MILITARY SPECIFICATION

INDICATOR, BEARING-DISTANCE-HEADING
ID-526A/ARN AND ID-798/ARN

This amendment forms a part of MIL-I-25992A(USAF), dated 10 SEP 59, and is approved for use within the Department of the Air Force and is available for use by all Departments and Agencies of the Department of Defense.

FIGURE 1. Pin Numbering

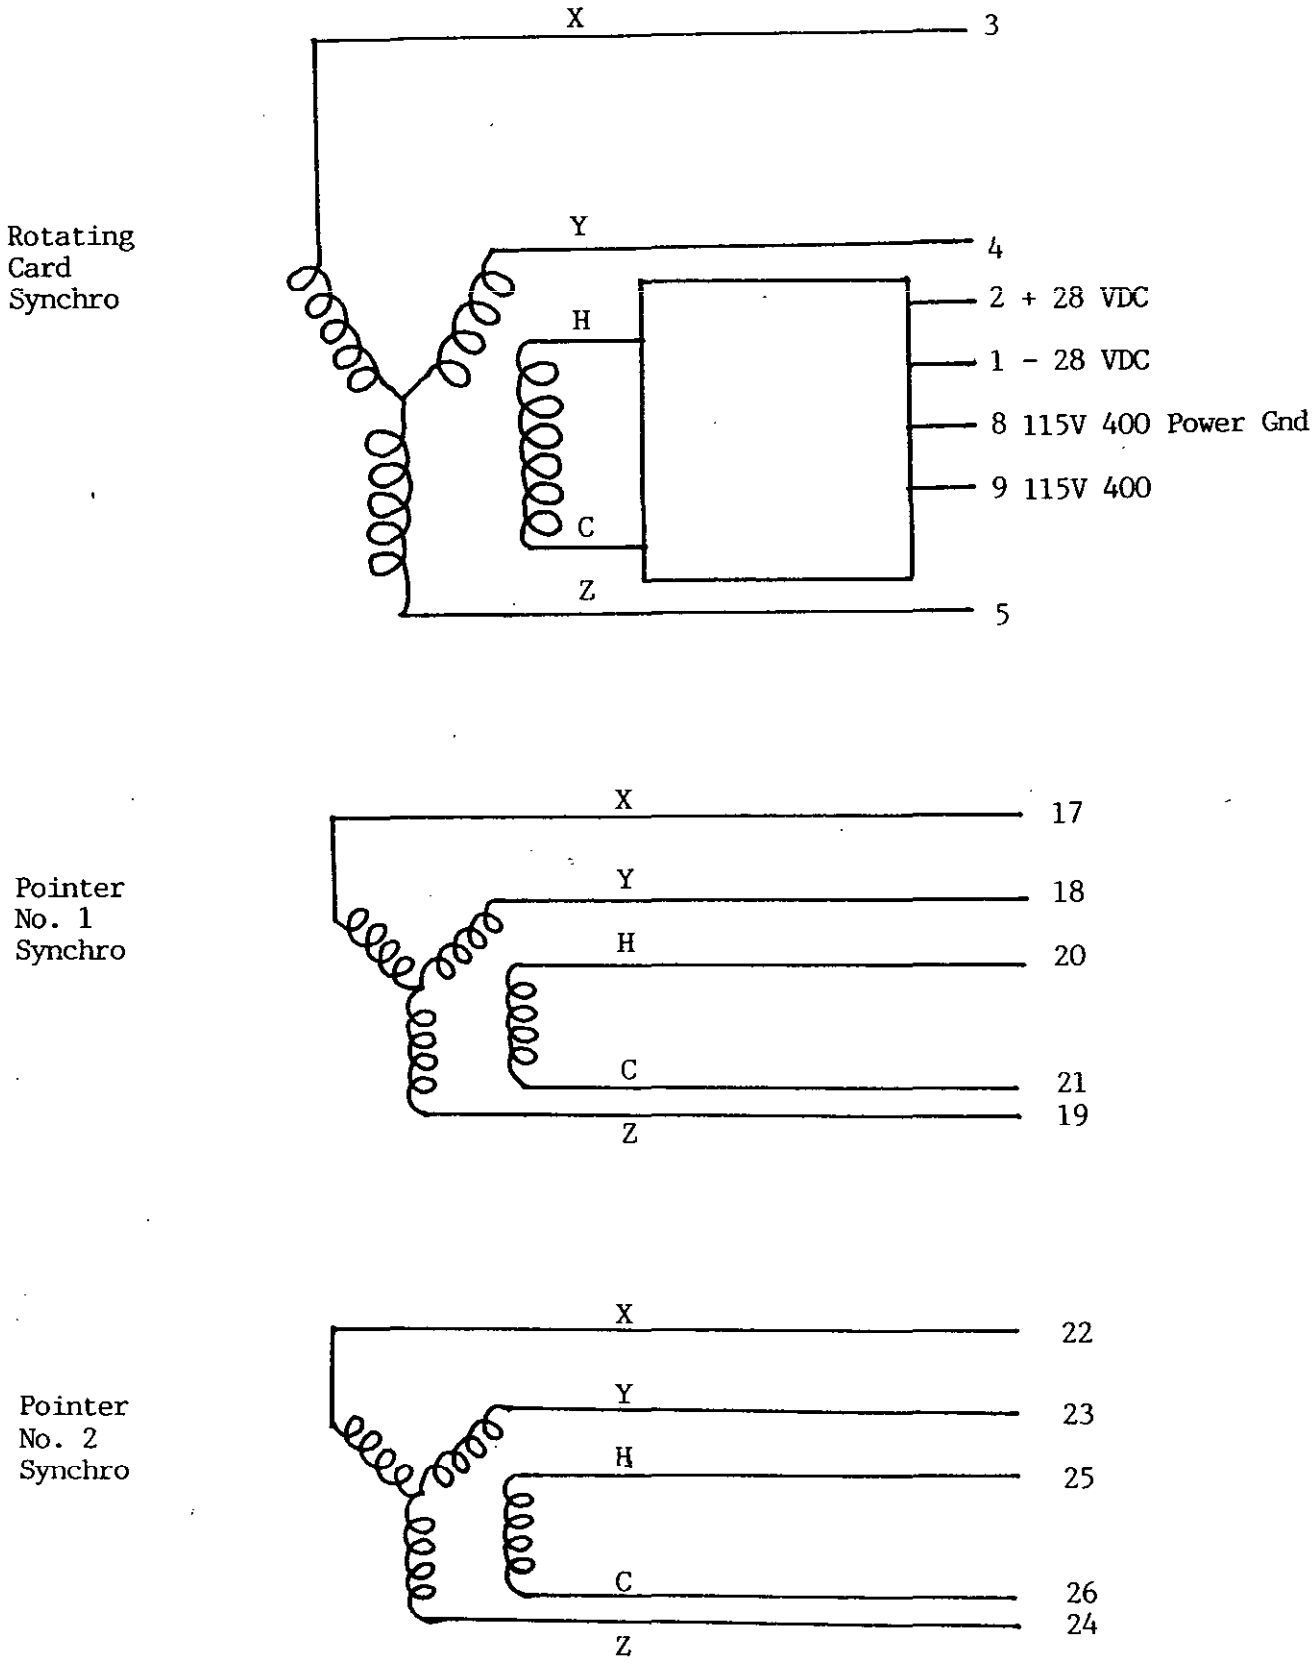
Replace "figure 1" in its entirety and add: "new figure 1" of this amendment on page 7.
